### Remarks

#### Amendments to the Specification and Drawings

#### Drawings Objections under 37 CFR 1.84(p)(5)

CPAC 1029-5

Fig. 6B

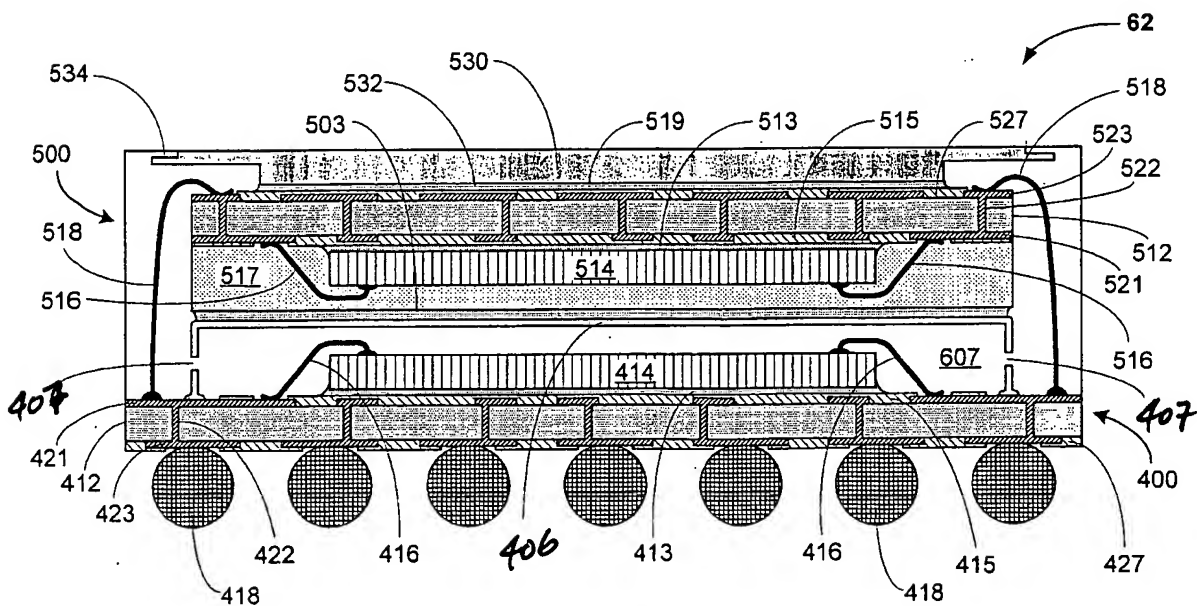
Additionally, Fig. 6B is amended herein by insertion of missing reference numeral 406, and 407 (2 instances), to be consistent with the description and with the reference numeration of Fig. 6A.

Fig. 7A

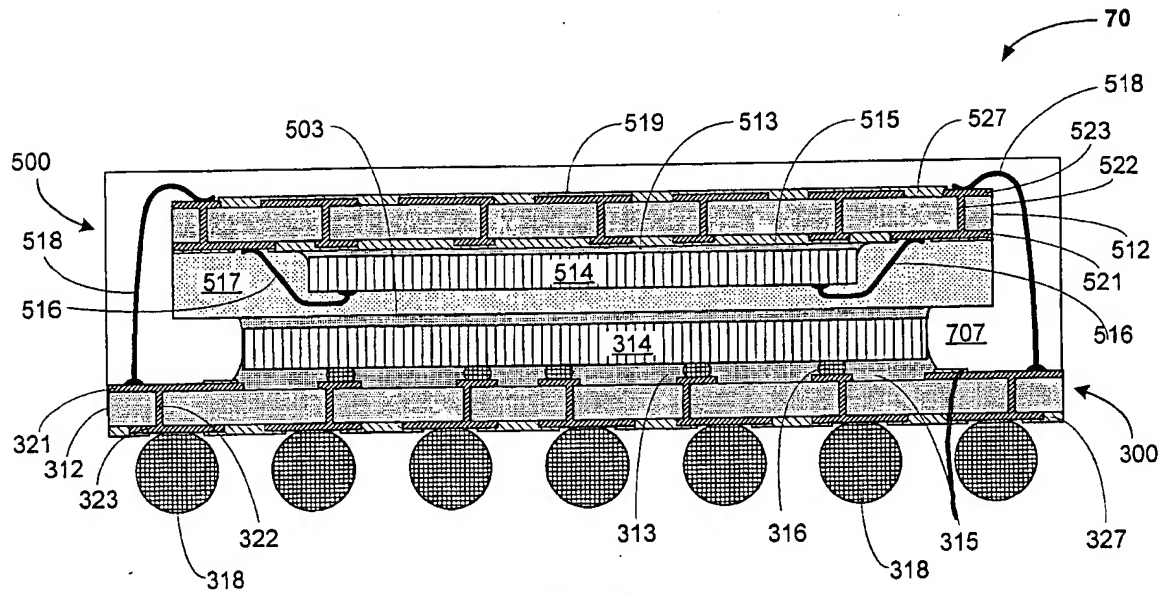
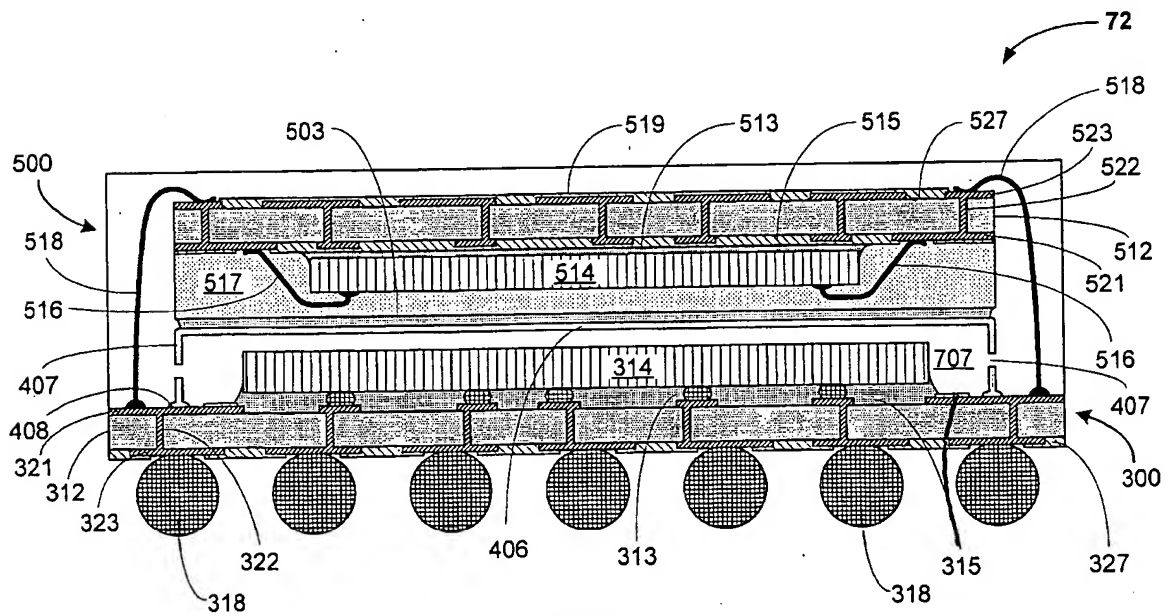
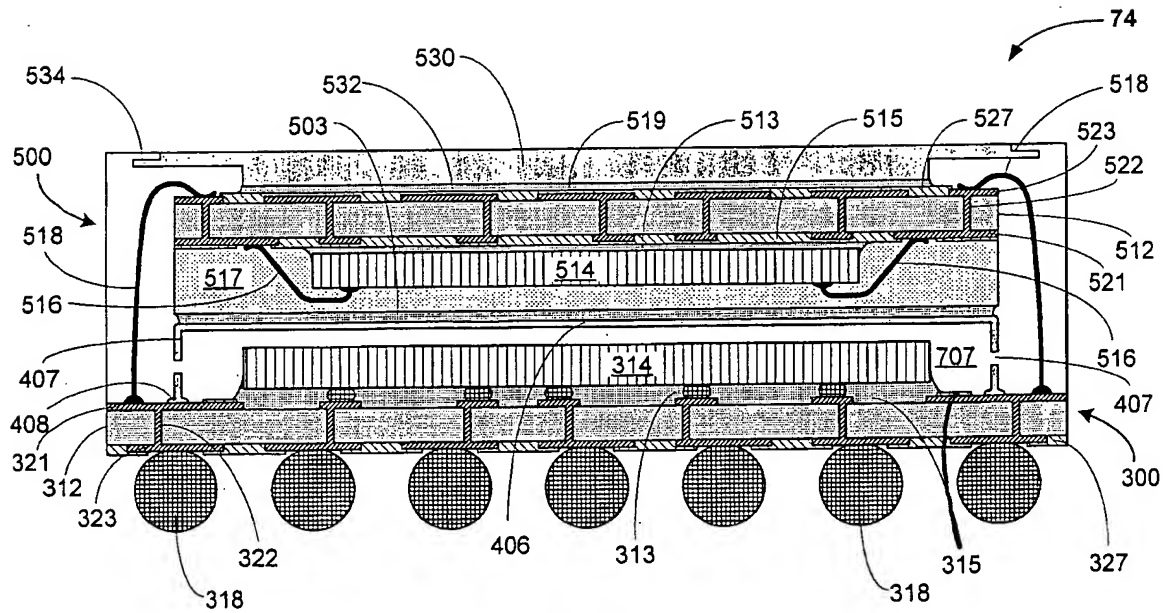
In Figs. 7A, 7B and 7C, the lead line from reference numeral 315 is moved, to indicate the “solder mask”, *see* paragraph [00140]. It is noted that reference numeral 313 indicates the underfill, *see* paragraph [00136].

Fig. 8B

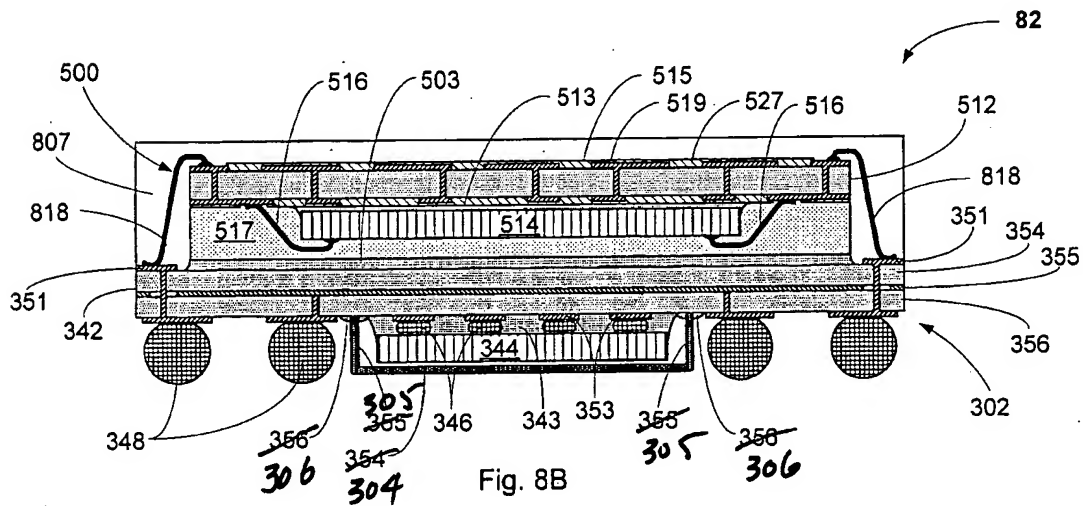
The attached sheets of drawings include changes to FIGs. 6B, 7A, 7B, 7C and 8B. Sheet 5 / 20, which includes FIGs. 6A and 6B, replaces original sheet 5 / 20 including FIGs. 6A and 6B; sheet 6 / 20, which includes FIGs. 7A and 7B, replaces original sheet 6 / 20, including FIGs. 7A and 7B; sheet 7 / 20, which includes FIG. 7C, replaces original sheet 7 / 20, including FIG. 7C; sheet 8 / 20, which includes FIGs. 8A, 8B and 8C, replaces original sheet 8 / 20, which includes FIGs. 8A, 8B and 8C. In FIG. 6B previously omitted reference numerals 406 and 407 (2 instances) are added. In FIG. 7A, 7B and 7C, the lead line running from reference numeral 315 is repositioned. In FIG. 8B reference numerals 304, 305 (2 instances) and 306 (two instances) replace erroneous instances of reference numerals 354, 355 and 356, respectively.

Fig. 8C

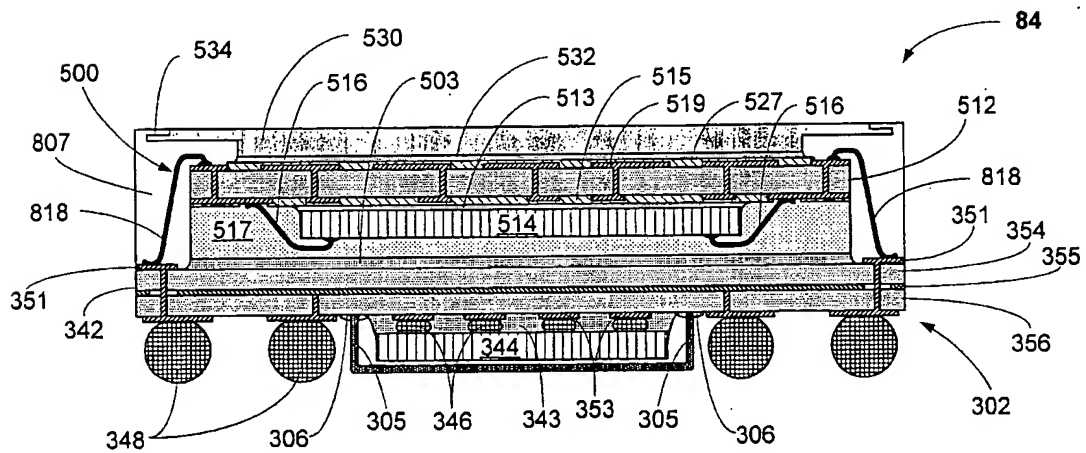
- 90, 92 -- is inserted following “embodiments of the invention” in paragraph [00180];
- “355” is replaced with -- 305 --, “356” is replaced with -- 306 --, and “354” is replaced with -- 304 -- (paragraph [00165]) to make the text consistent with the reference numeration of FIG. 8C and to avoid use of any reference numeral to identify more than one feature. It is noted that metal layer 355 is sandwiched between dielectric layers 354, 356 in bottom package substrate 342 (*see, e.g.*, paragraph [00157], Figs. 8A, 8B, 8C). Accordingly, Fig. 8B is amended to make the reference numeration consistent with that of Fig. 8C, by replacing the instances of reference numerals 354, 355, 356 that are directed to the lower planar part and the legs or sidewalls of the heat spreader, and the adhesive by which the heat spreader is affixed to the substrate, with, respectively, numerals 304, 305, 306;
